## DESCRIPTIVE REPORT

Type of Survey ..... Hydrographic  
Field No. .... RA-20-1-87  
Registry No. .... H-10244

State ..... Alaska  
General Locality ..... Bristol Bay  
Sublocality ..... Kulukak Bay and Vicinity

## Descriptive Report to Accompany Hydrographic Survey H-10244

Example of offsets between final field sheet and plot using data tape information.

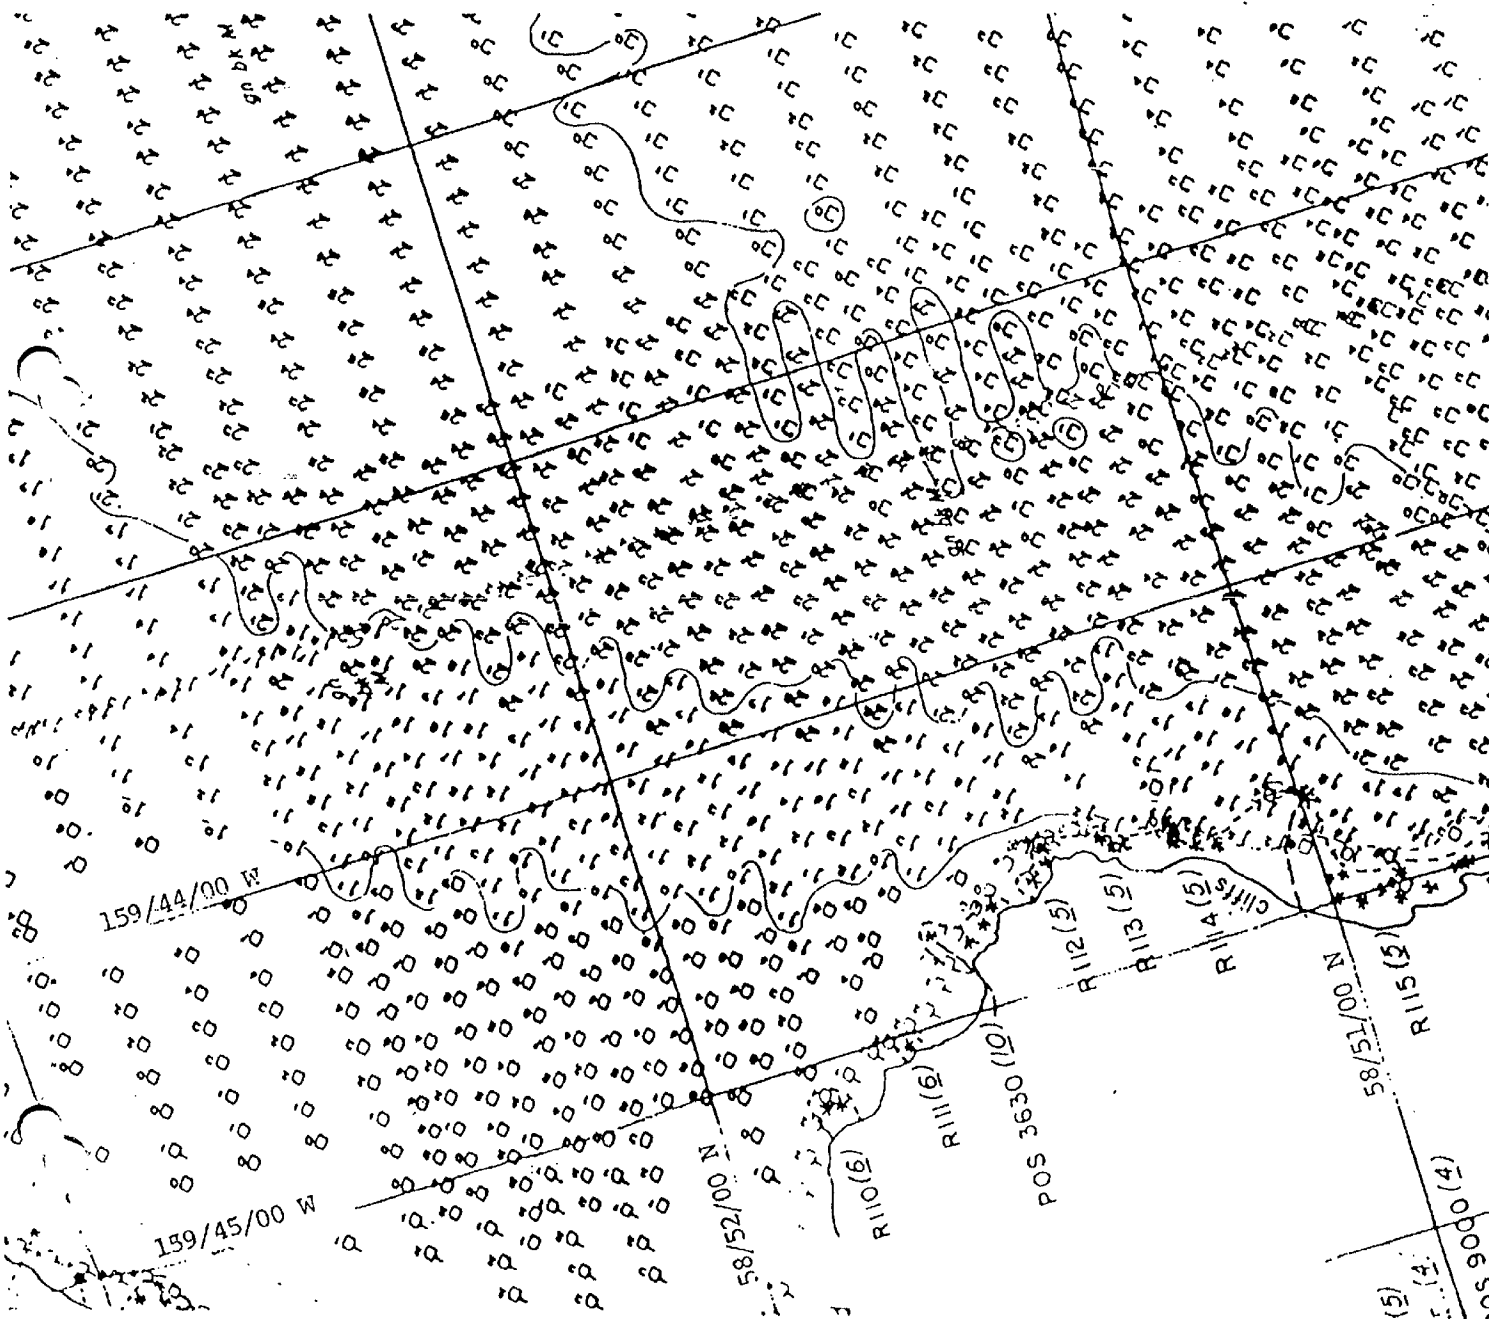
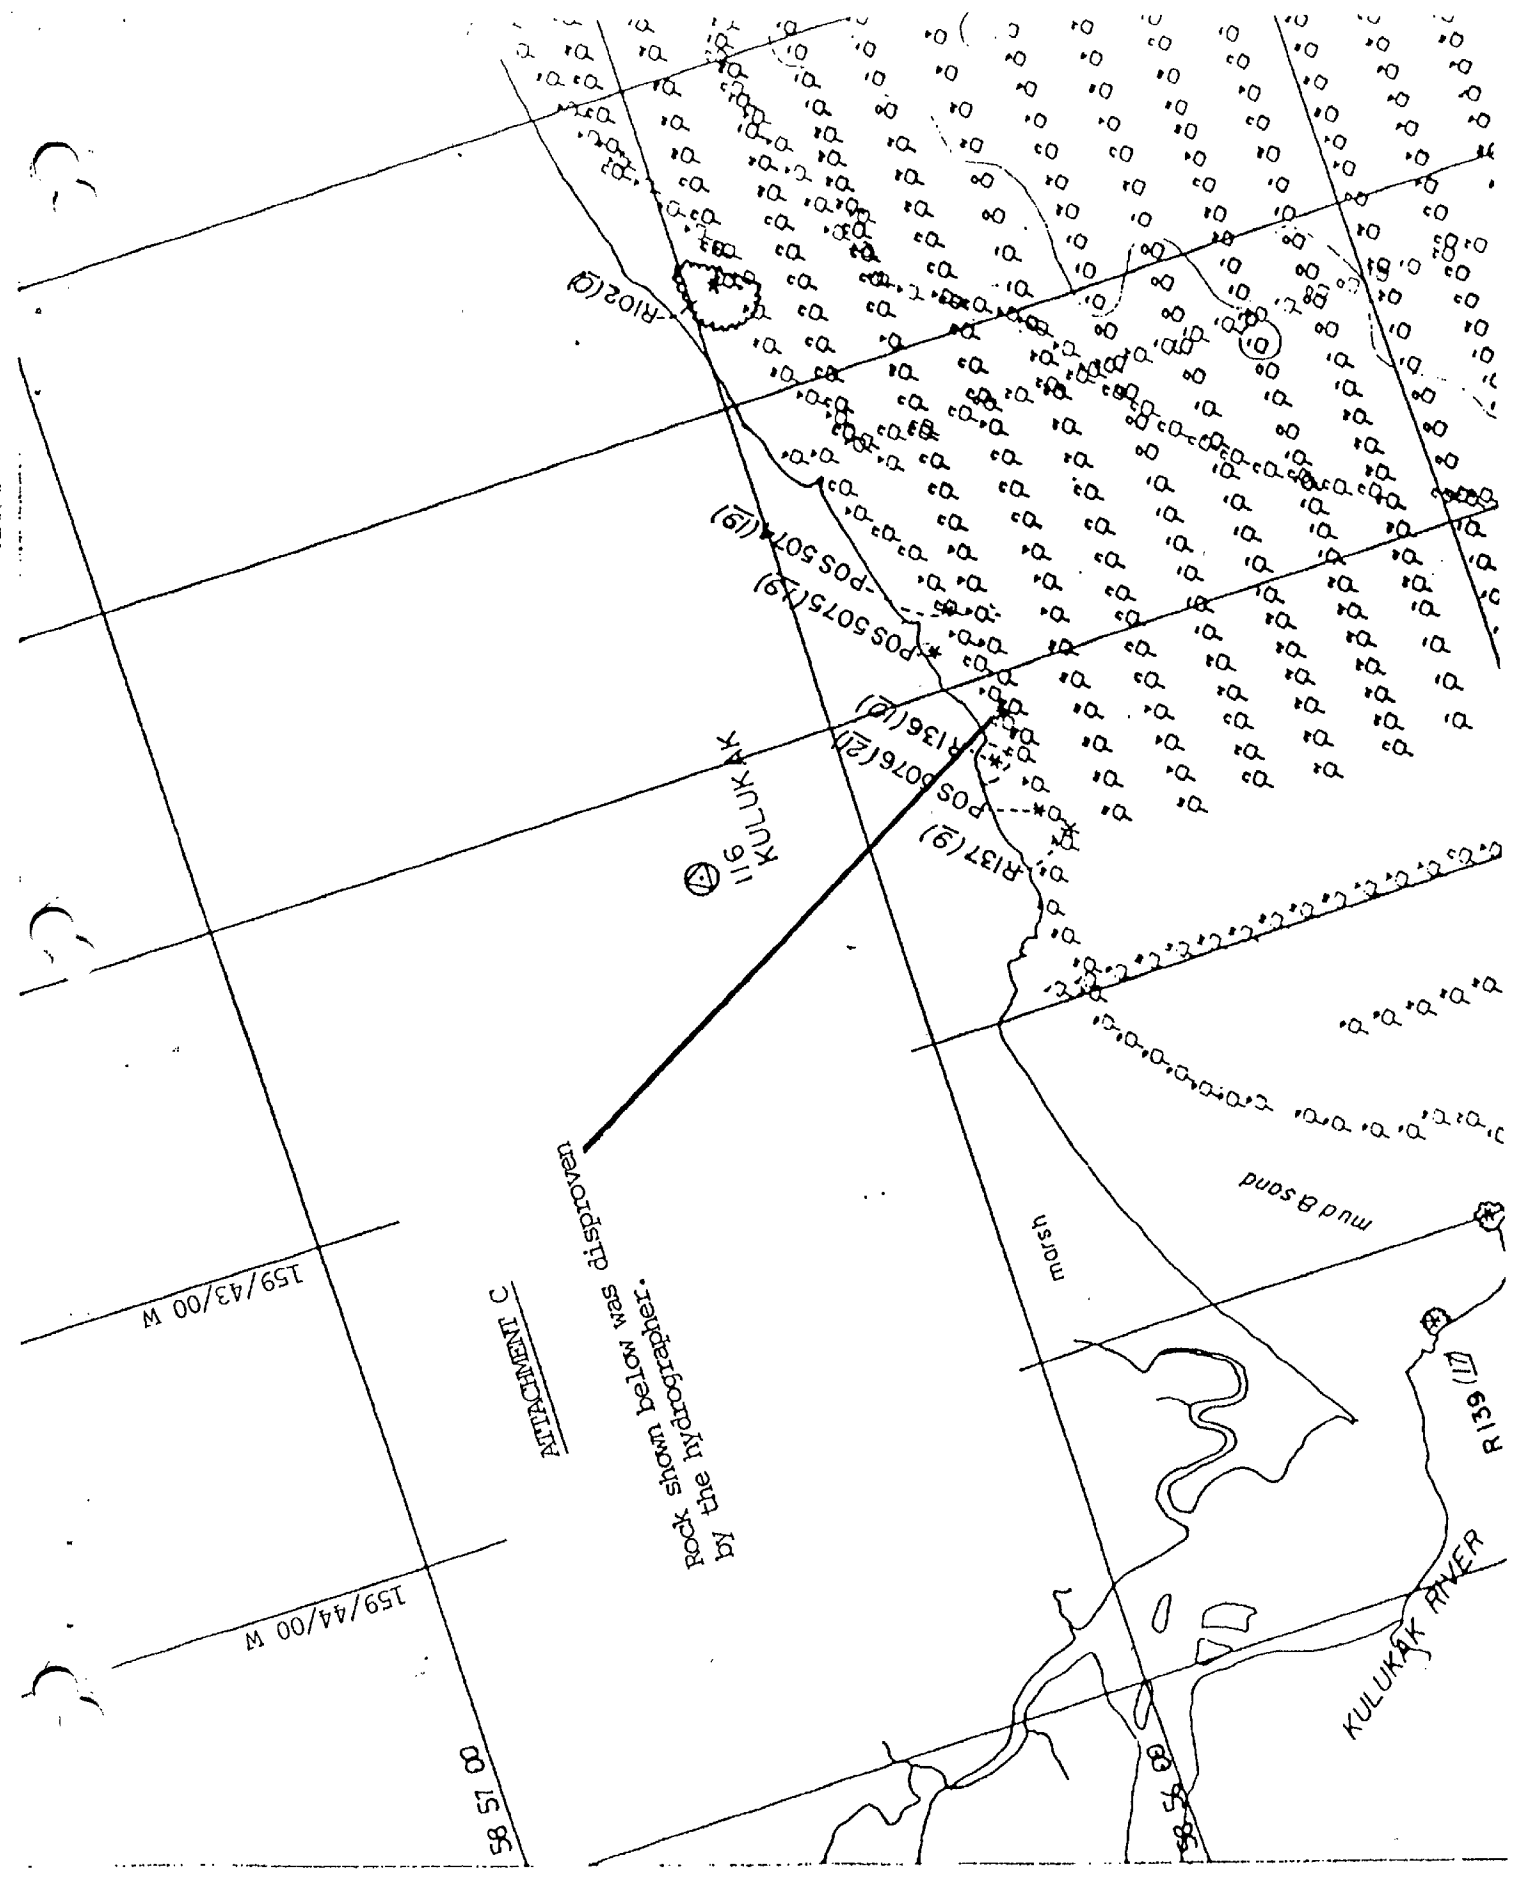
Control stations and approximately 15 DPs on the final field sheets appear to be plotted 40m-70m south of the positions generated from data tape information. Geographic positions of control stations are correct on the signal tape. It appears the errors may originate from positions transferred manually to the final field sheet or from an intermediate plot with an inconsistent grid (see Attachment A). Soundings appear to be plotted correctly.

As an example, the latitude of position no. 9006 is 58/51/00.85N. Final field sheet shows position below 58/51/00N.

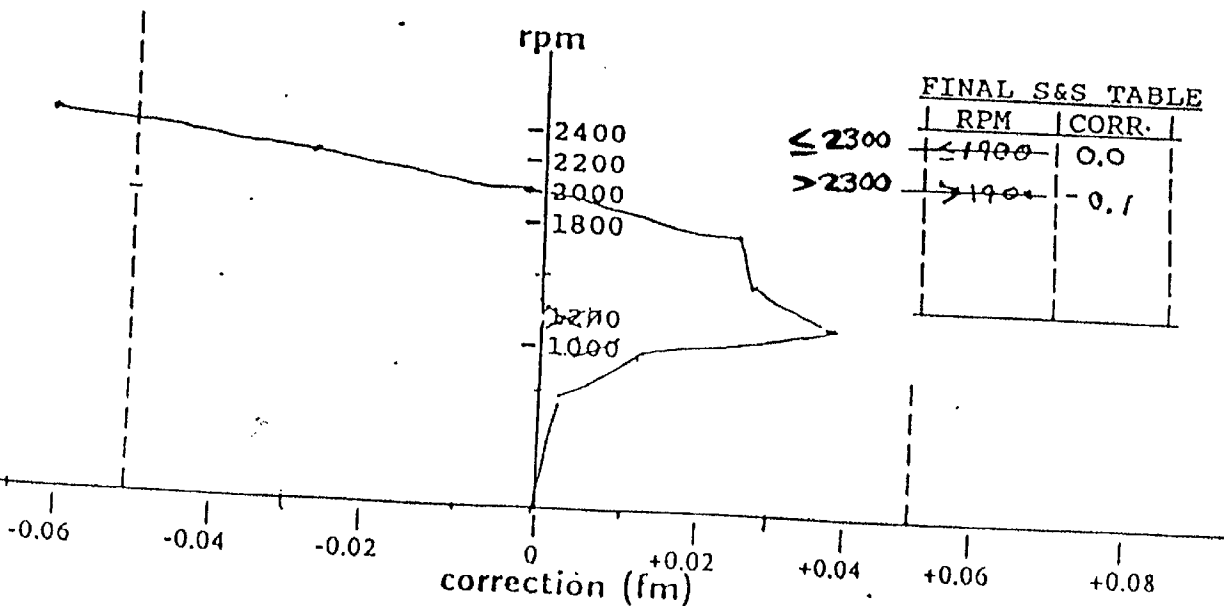
An incorrect depth of an inserted sounding was noted on the echogram for vessel number 2124, DN 161. The actual depth of the shoal is 2.0fms; the insert on the echogram and the unchecked corrector tape listing state 2.2fms. A notation for the insert on the raw data printout had been corrected from 2.2fms to 2.0 fms (see Attachment D). It is probable similar errors and inconsistencies exist within the survey data. Echograms and tape listings should be carefully reviewed to ensure changes and additions to the raw data are correct and complete [HM 4.8.1, 4.9.8.1].

Corrector tape does not reflect the change to the master tape printout for the least depth of the inserted peak.
